VALUE ENGINEERING REPORT

**US 19/41/SR 3 / Tara Boulevard
Widening and Reconstruction
NH000-0001-04(060); PI No. 722030
Clayton County**

May 14, 2012

PROJECT OWNER:

Idea No.: A-2
Client: GDOT
Sheet 2 of 4

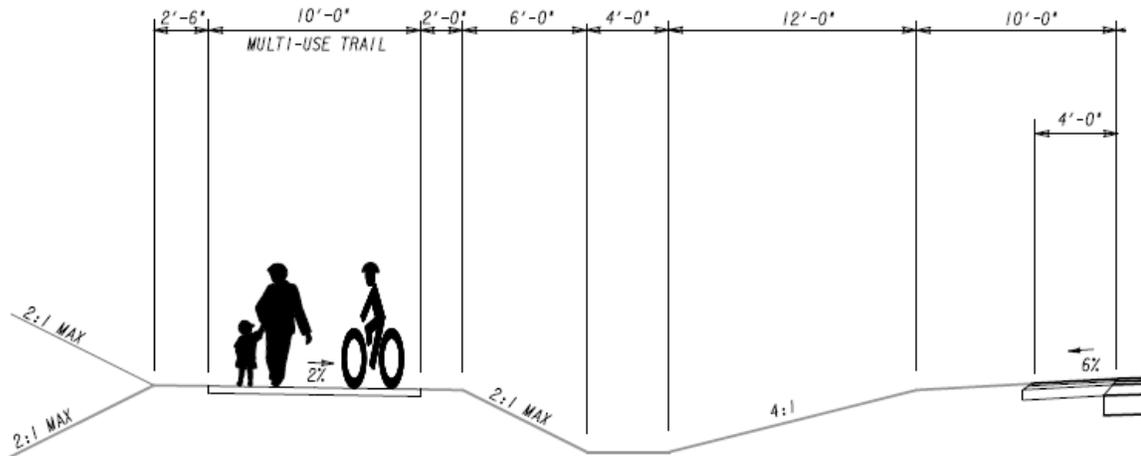
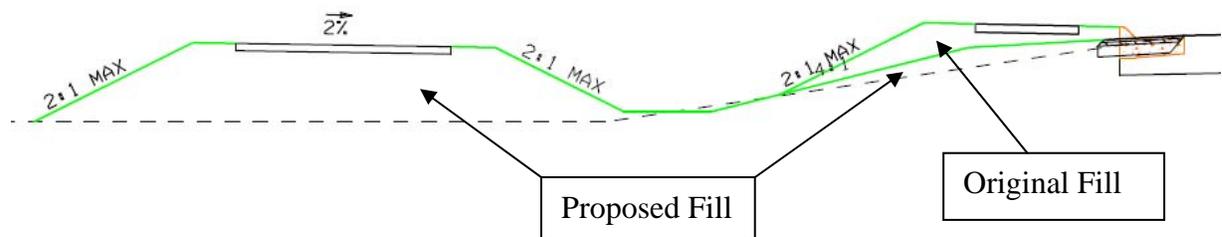
Original Concept: Provide curb and gutter with a 5' concrete sidewalk on west side. Also provide on-road bike lanes with buffer offsets in each direction.

Proposed Change: On the west side, develop a 10 foot wide multi-use path and eliminate the curb and gutter; provide a rural ditch section. Remove the on-road bike lanes and buffer offsets in each direction.

Justification: Constructing a dedicated, off-road multi-use trail will provide a more user-friendly path. Removing the on-road bike lanes will reduce the pavement width and eliminate the required buffer offset for a 55 mph design speed. There is ample room within the existing right-of-way for the multi-use trail. Additionally, this appears to be a low use corridor for both pedestrian and bicyclists and combining the usage provides efficiencies. If, in the future, this corridor is further developed and pedestrian and bicyclist usage picks up, there is still ample room to widen on both sides.

This recommendation reflects a rural ditch section on the west side however the multi-use trail concept would also work with an urban section, on either side of the road.

Idea No.: A-5
Client: GDOT
Sheet 2 of 5

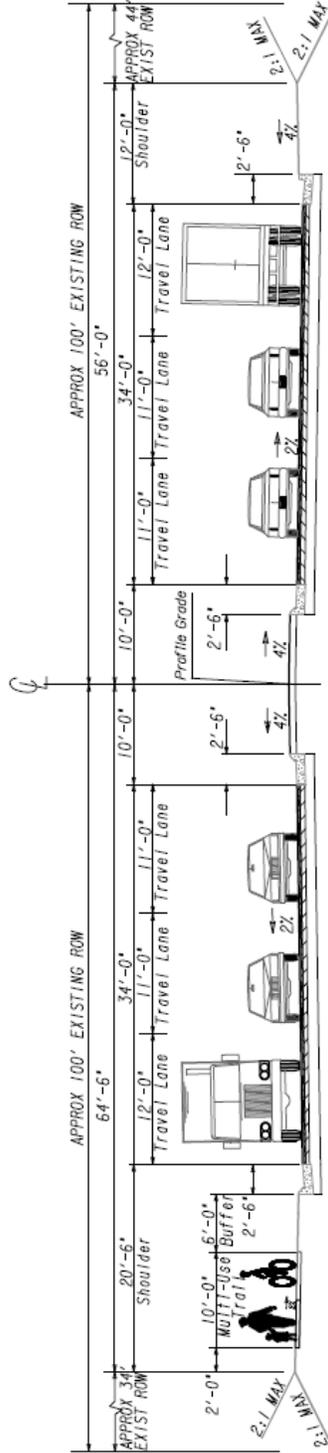
Original Concept: Use 55 mph design speed

- Widen 4 Lanes to 6 Lanes. 1-12' outside lane and 2-11' lanes.
- OGFC and SMA used for surface layers.
- 18' Raised median including 2 foot paved shoulder each side of median
- Urban southbound shoulder with 8' paved shoulder containing a 4' buffer and a 4' bike lane
- Rural northbound shoulder 6.5' wide with 4' bike lane
- 5' wide sidewalk on southbound side only

Proposed Change: Use 45 mph design speed

- Replace OGFC and SMA used for surface layer with 12.5 mm superpave
- Use standard 20' raised median.
- Provide urban northbound and southbound shoulders with no buffers or bike lanes.
- Construct a 10' wide, multi-use trail on southbound shoulder.

Justification: Using a 45 mph design speed allows additional flexibility in the design guidelines and offers the design team additional options for more appropriate and project specific typical section elements. This recommendation incorporates the desirable options however they can also each be analyzed and reviewed on an individual basis.

- 20' raised median allows for more opposing lane separation at turn bays than 18' median. In addition, 4' feet of additional full depth paving adjacent to the median could be eliminated.
- Urban northbound and southbound shoulders
 - Reduces roadway footprint. This template will fit within the existing 200 ft right-of-way
 - Offset buffer is not required for urban shoulders at 45mph.
 - Moving the bike lanes to a multi-use trail on the shoulder eliminates additional bike lane pavement and provides separation for pedestrians and bikers from the projected 88,000 vehicles.

Idea No.: A-10
Client: GDOT
Sheet 2 of 4

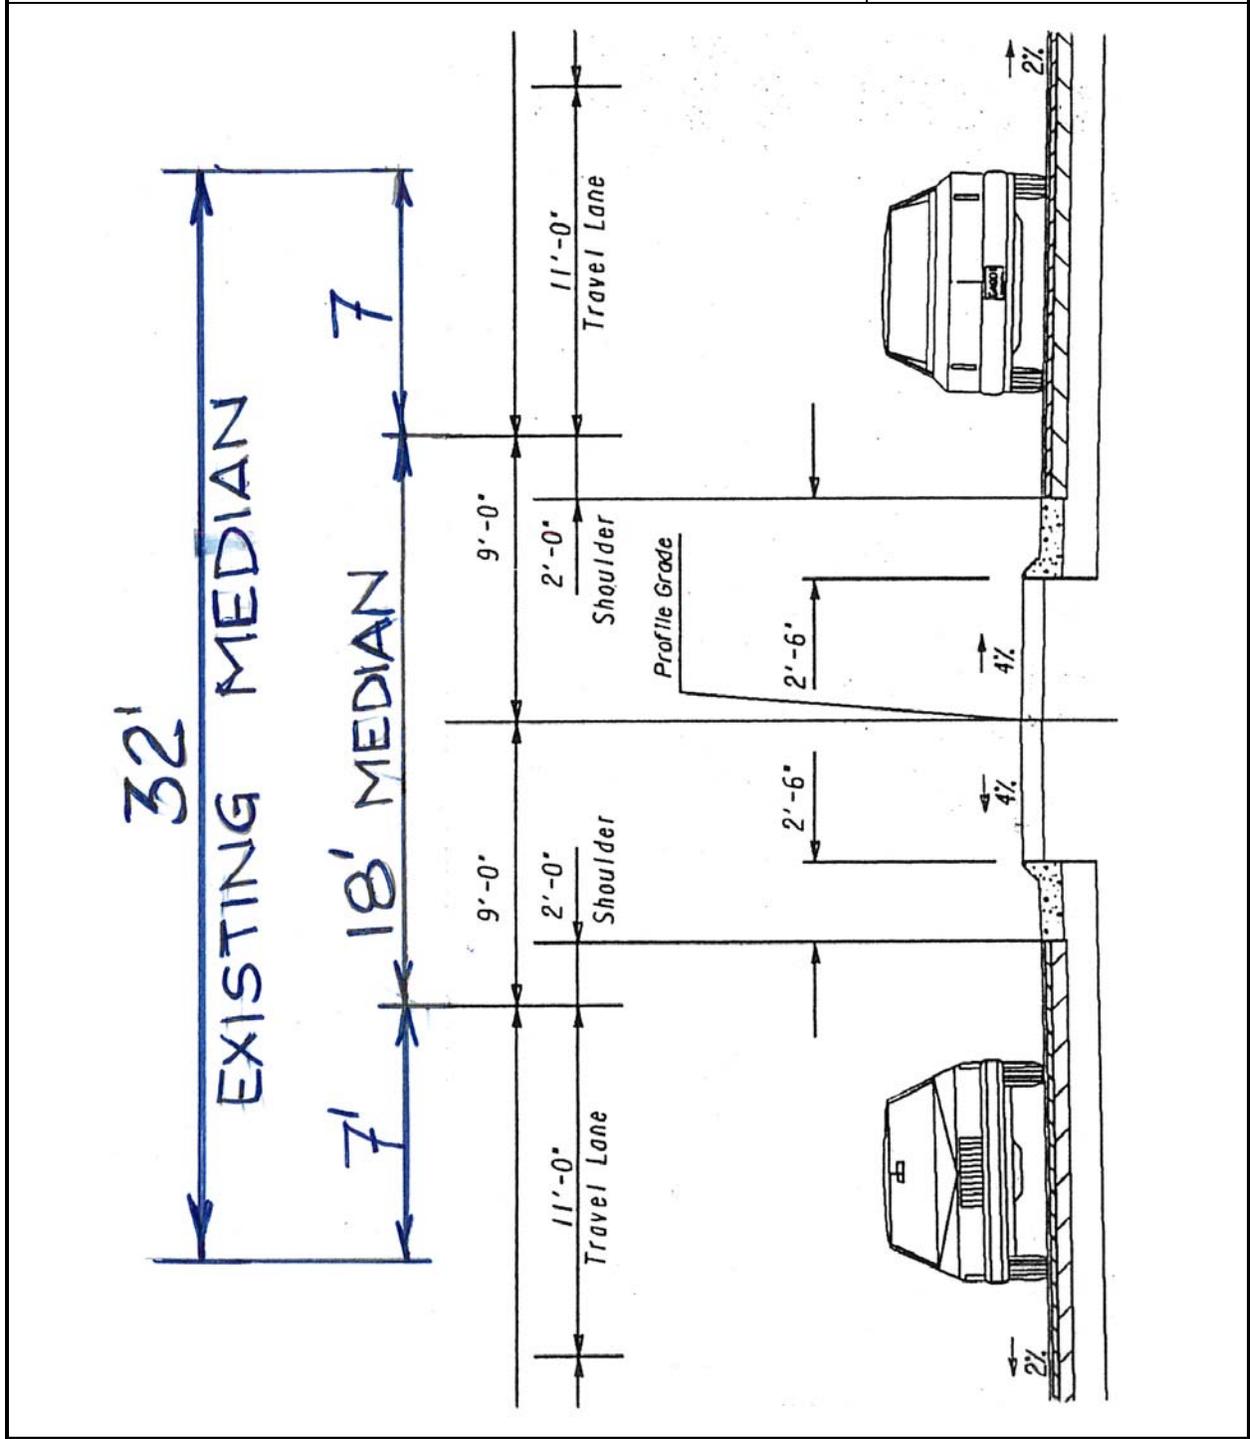
Original Concept: Use an 18 ft raised median with concrete surfacing and Type 7 concrete curb and gutter. Widen symmetrically about the centerline which requires roadway widening and full-depth pavement construction to both the inside and outside of the existing roadway template.

Proposed Change: Retain and re-use the existing 32 ft wide depressed, grassed median and construct all new widening to the outside.

Justification: Since the existing right of way width is 190/200 feet, utilizing the existing 32 ft median and constructing all widening to the outside will allow a wider median and eliminate most interior work. There is ample room within the existing R/W to accommodate the required template even with other considerations such as a combined multi-use trail and rural ditch sections. As compared to the 18 foot proposed median width, a shift of only 7 feet would be required (half-section);

$$32 - 18 = 14 \text{ ft} / 2 = 7 \text{ ft}$$

Additionally, the wider median will allow a larger recovery area and is in conformance to GDOT guidelines for a 55 mph roadway. If all full-depth pavement construction is limited to the outside, the construction staging and maintenance of traffic should be more easily accommodated.

Idea No.: D-2
Client: GDOT
Sheet 2 of 4

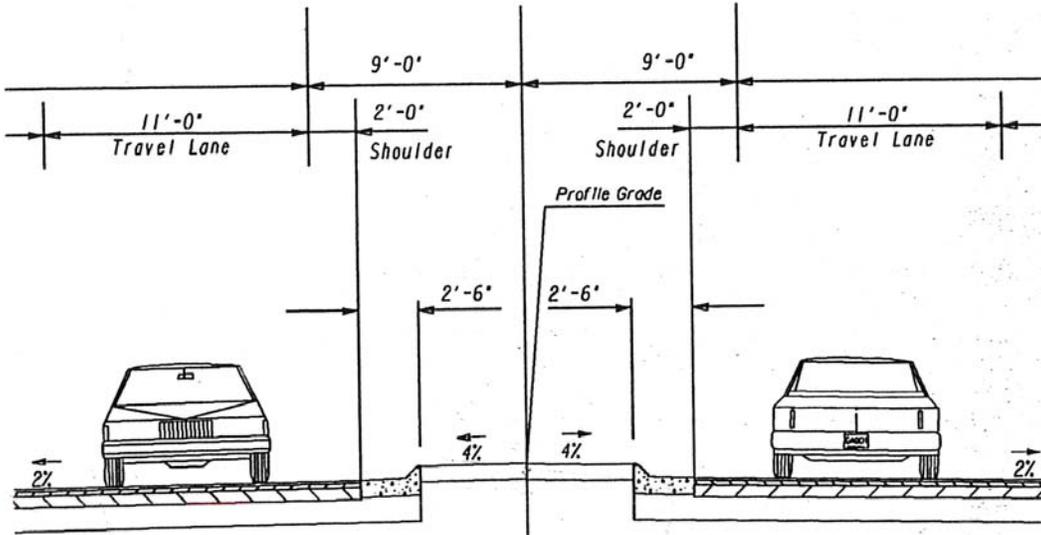
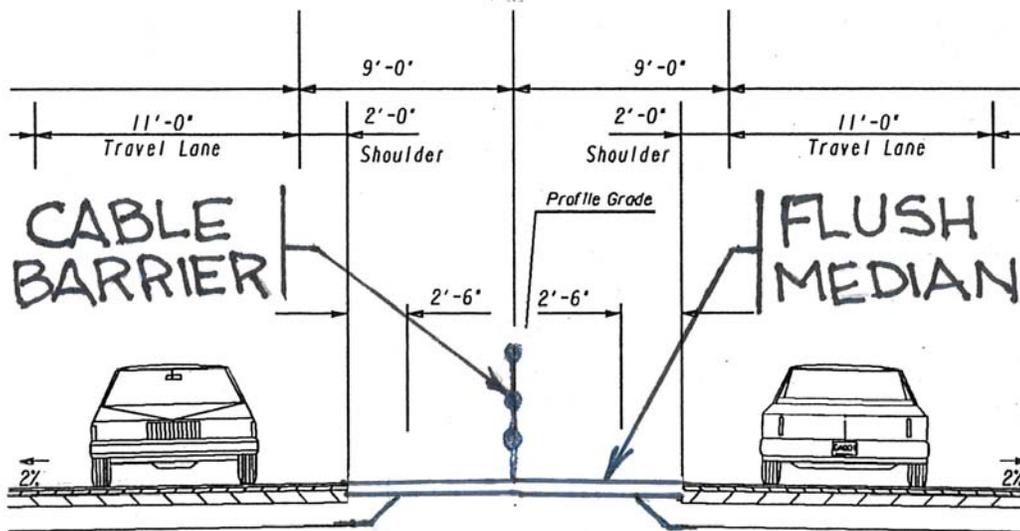
Original Concept: Use a raised median with concrete surfacing and Type 7 concrete curb and gutter.

Proposed Change: Use a grassed median with cable rail and eliminate the mountable curb and gutter and concrete surfacing.

Justification: Using cable railing will provide a positive barrier between opposing directional traffic which will be a concern with a narrower median and mountable curbing. This recommendation is especially more appropriate if a 55 mph design speed is maintained for this project. At higher speeds, a positive barrier is more desirable to minimize crossover incidents.
